ADDENDUM 1
RFB #17-0038
RONALD REAGAN BUILDING RENOVATION-FLOORS 4,5,6

**RONALD REAGAN BUILDING RENOVATION – FLOORS
4,5,6
Sedgwick County**

Prepared by:
Schaefer Johnson Cox Frey Architecture, Inc.

A LEVEL 6 - NEW CONSTRUCTION PLAN - POWER
 SCALE: 1/8" = 1'-0"
 NORTH

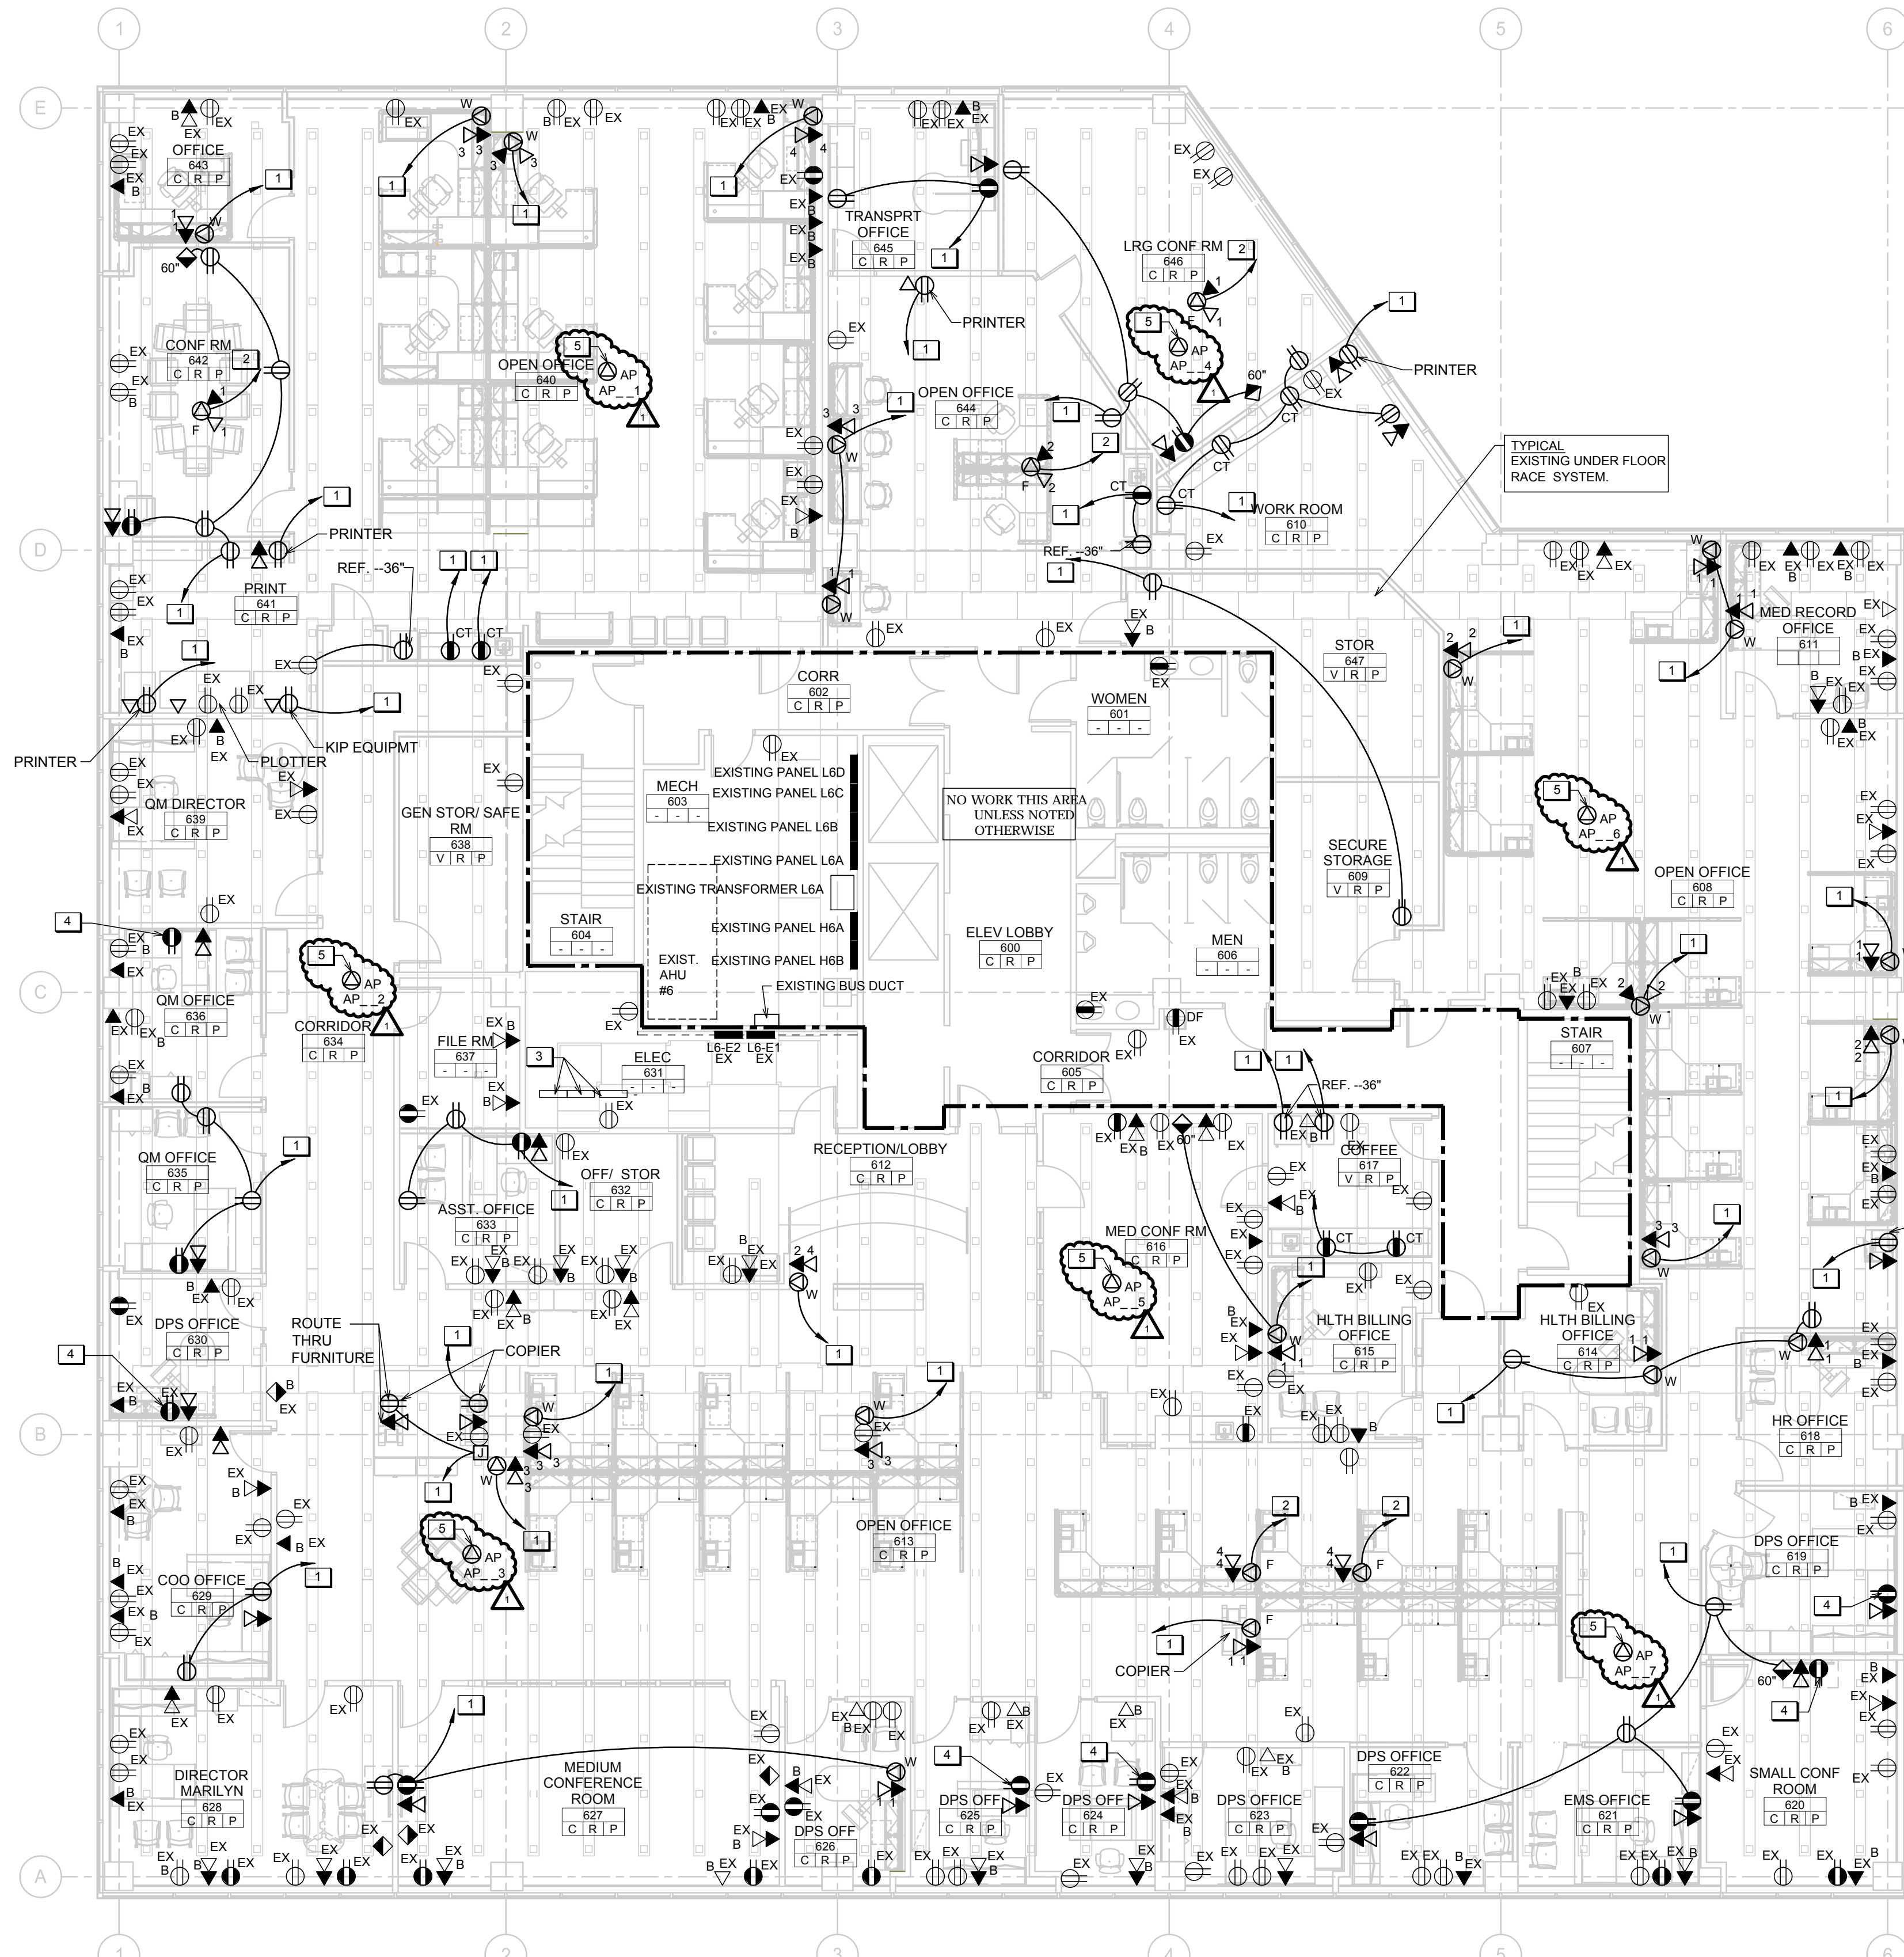
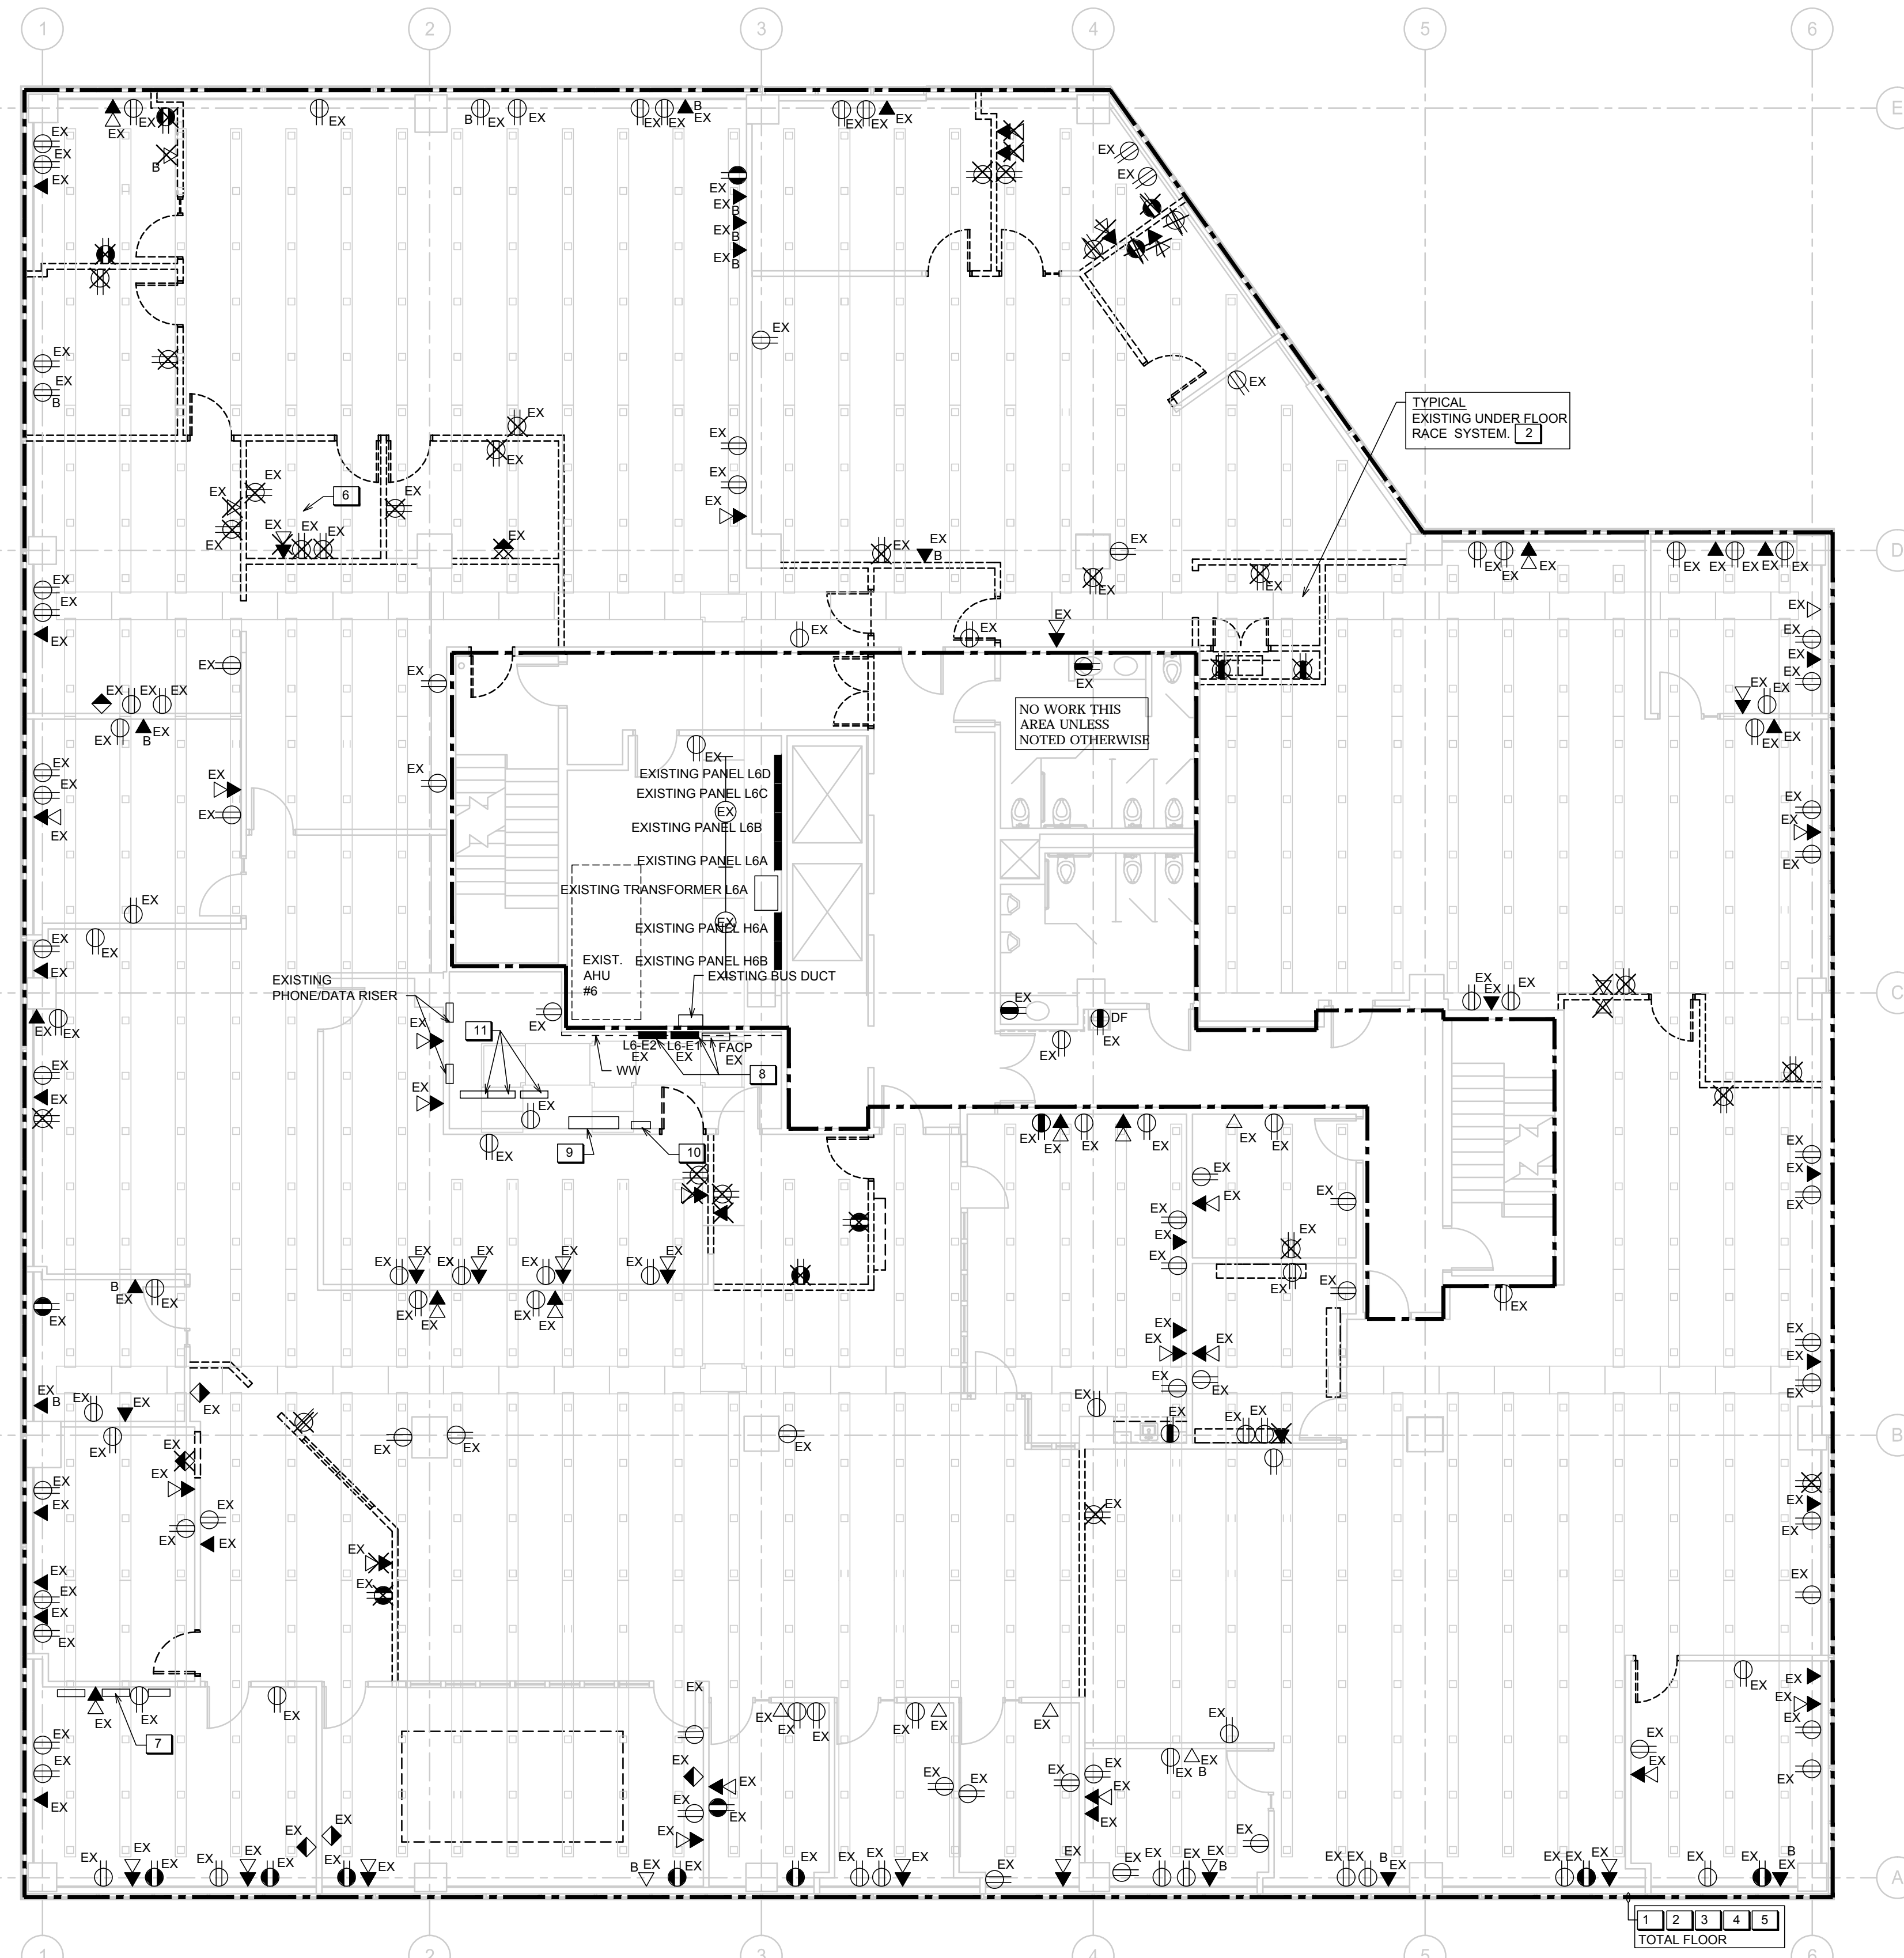
5 **ITEM AD1-E01** PLAN SHEETS E23.1, E24.1, E25.1:
ADDITION: Add cabling for Wireless Access Points per symbol type "AP" and plan notes
5 and 6 per attached sheets E23.1R, E24.1R and E25.1R.
